BID ADDENDUM NO. 3

Date of Addendum: January 18, 2024
Issued for Bid Date: December 18, 2022
Client Name: Eastchester Union Free School District
Project Name: 2022 Capital Bond Project, Phase 3
SED Project No.: Anne Hutchinson Elementary School: 66-03-01-03-0-001-023
Eastchester Middle / High School: 66-03-01-03-0-003-031
MEMASI Project No.: 102-2301
Contracts: Contract No. 1 – General Construction (GC)
Contract No. 2 – Mechanical Construction (MC)
Contract No. 3 – Electrical Construction (EC)
Contract No. 4 – Plumbing Construction (PC)

GENERAL NOTES, RTU FRAMING PLAN & DETAILS

MSHS S-100

MSHS M300

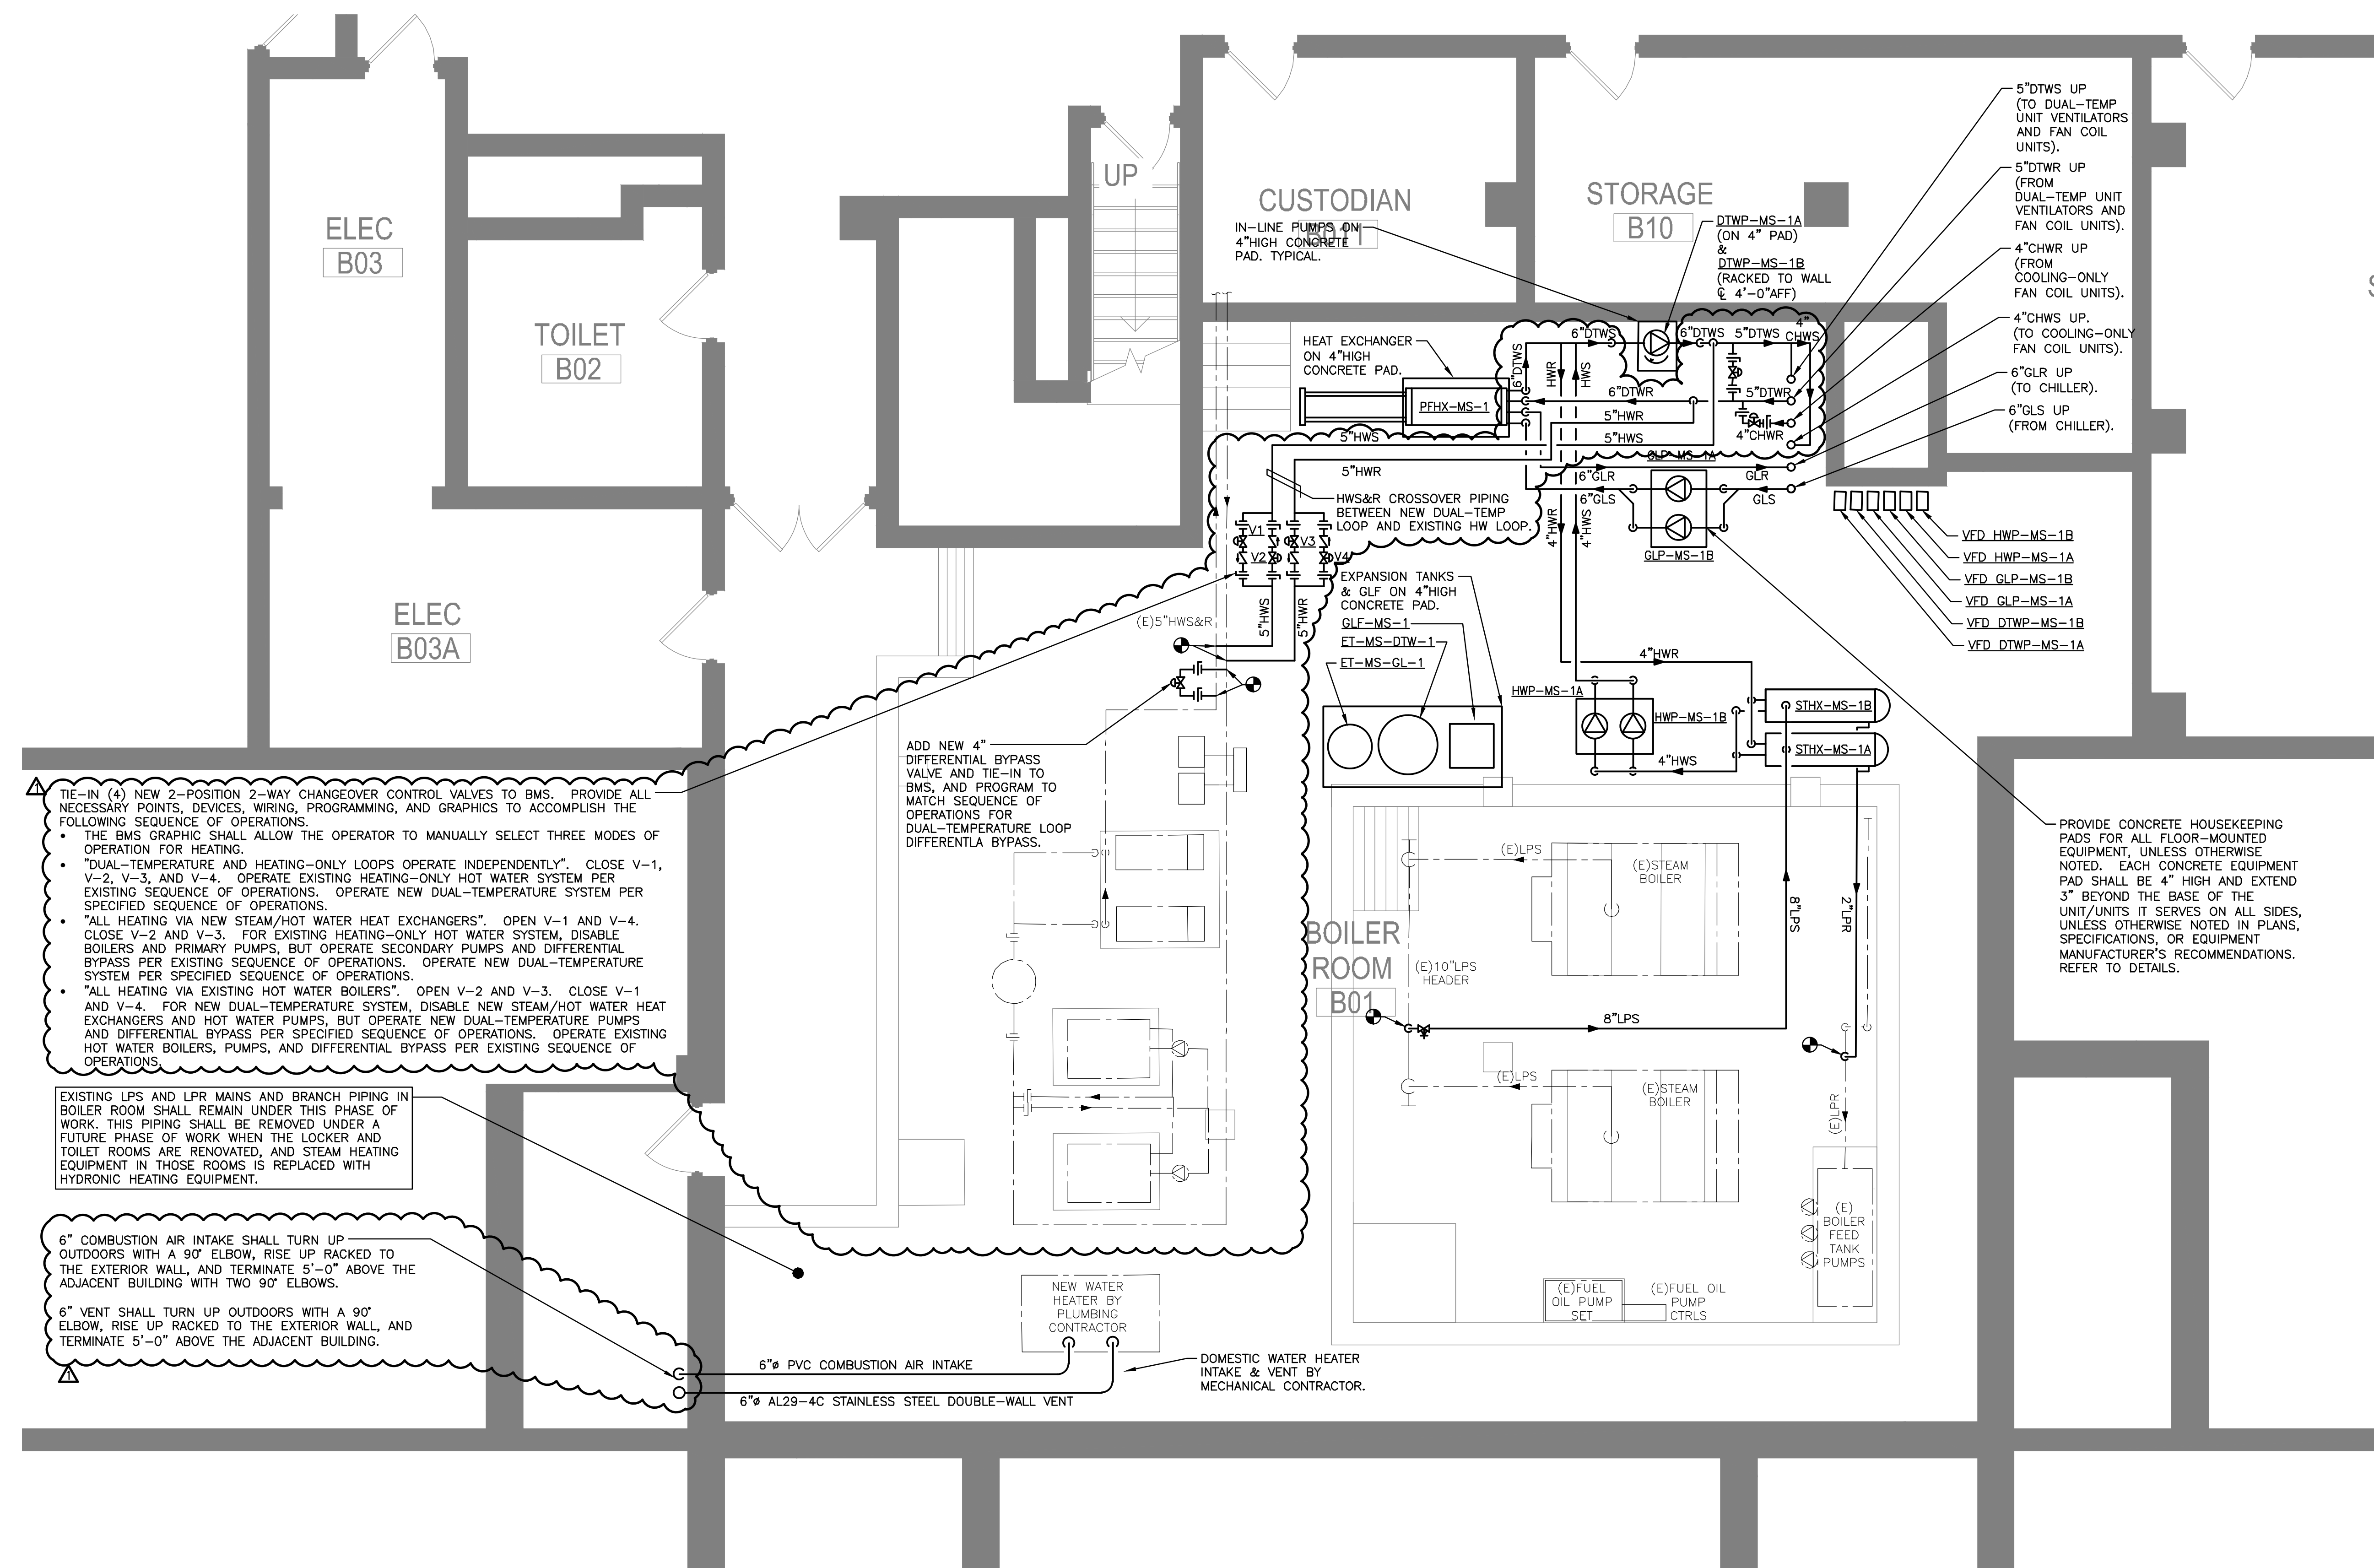
8. **MSHS M300 – MECHANICAL PART PLAN – MIDDLE SCHOOL BOILER ROOM**
 - a. The drawing shall be revised to add hot water supply and return cross-over piping between the new dual-temperature system and existing heating-only hot water system, along with associated control valves and BMS controls.

- b. The drawing shall be revised to indicate that the 6” combustion air intake for the domestic hot water heater shall turn up outdoors with a 90° elbow, rise up racked to the exterior wall, and terminate 5’ above the adjacent building with two 90° elbows.

- c. The drawing shall be revised to indicate that the 6” vent for the domestic hot water heater shall turn up outdoors with a 90° elbow, rise up racked to the exterior wall, and terminate 5’ above the adjacent building.

Drawing MSHS M300 shows 6" PVC Combustion Air Intake and 6" AL29-4C Stainless Steel Double Wall Vent penetrating wall into an outdoor stairwell with ladderway, but does not show the continuation of flues, please advise where these are to terminate.
